V8 XJ Series/XK

303-S514

# TECHNICAL BULLETIN

## Operation Of Throttle While In Closed Position – Service Action S514

ILLUSTRATION 16

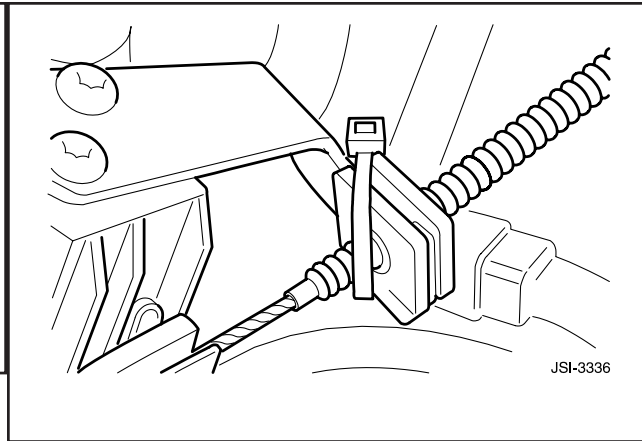
16. **⚠ WARNING: FOR VEHICLES WITH THE PLASTIC ADJUSTMENT NUT, AFTER CORRECT CABLE ADJUSTMENT, YOU MUST INSTALL A RATCHET TIE STRAP TO FULLY RETAIN THE ADJUSTER NUT IN ITS LOCATION WITHIN THE ABUTMENT BRACKET, (ILLUSTRATION 16) REFER TO RECALL ACTION R466.**
